CENTRAL PARK ESTATES SOUTH JSP23-22

Public hearing at the request of Nobe Property Group II, LLC for JSP 23-22 Central Park Estates South for Preliminary Site Plan, Wetland Permit, Woodland Permit and Storm Water Management Plan. The subject property is zoned RM-2 (High Density Mid Rise Multiple Family) and is approximately 7 acres. It is located south of Grand River Avenue on the east side of Beck Road, in Section 16. The applicant is proposing a multifamily development with 142 units in a single 5-story building. The site improvements include parking on the first level of the building as well as surface parking, and related open space amenities.

MOTION SHEET

sheet no.
LP.02

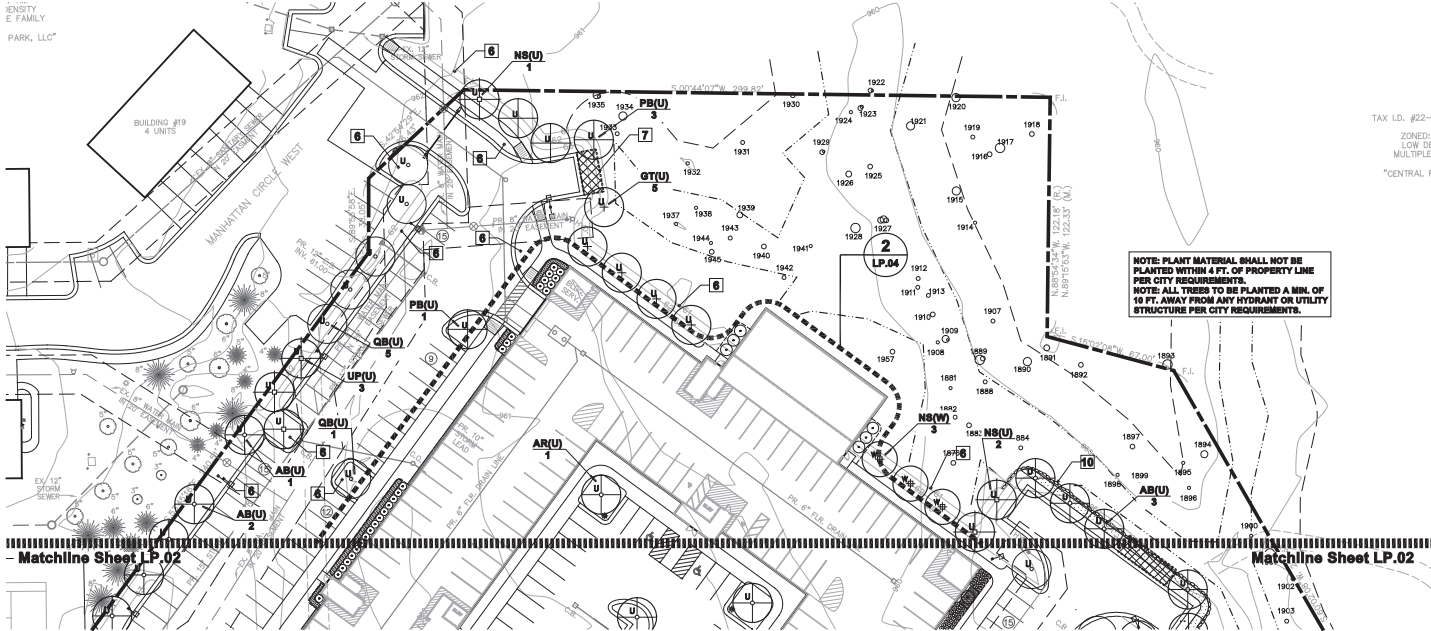
Item	Required	Proposed	Meets Code	Comments
				<p>are to be landscaped per the detail.</p> <p>3. Please add the city transformer screening detail to Sheet LP-05</p> <p>4. Please add an allowance of 10 shrubs per box on the plant list and label as such</p>
<p>Detention/Retention Basin Planting requirements (Sec. 5.5.3.e, LDM 3)</p>	<ul style="list-style-type: none"> Clusters of large native shrubs shall cover 70-75% of the basin rim area at 10 ft away from the permanent water line. Canopy trees must be located at 1 per 35lf of the pond rim 10 feet away from the permanent water level 10" to 14" tall grass along sides of basin Refer to wetland for basin mix Include seed mix details on landscape plan 	<ul style="list-style-type: none"> Seed mixes are proposed for the detention pond Required shrubs are proposed. Canopy trees are proposed along the east, south and west sides of the pond Seed mix is indicated and details are provided 	<ul style="list-style-type: none"> Yes Yes Yes 	<p>Please add a note stating that "The contractor shall send proof of the native mix to be used in the form of a photo of the seed bag or copy of the invoice to meader@cityofnovi.org for approval prior to planting."</p>

9. Hydrant separation - See response above.
 - a. FDC is clear of plantings. See SW corner of building.
10. Transformer is shown on plans.
 - a. Added 10 shrub allowance to plant list as requested.
 - b. Added City detail as requested.
11. Basin Plantings - Seed note added to plans.
12. Plants - 50% native plants in revised plant lists.
13. Tree cost revised.
14. No overhead power lines - see note on plans.
15. Irrigation Plan to be provided at Final Site Plan as required.
16. Understory - 11 Serviceberry (8 Ft. Ht.) shown on sheet LP-02.
17. Overhead utilities - none. See note on plans as submitted.
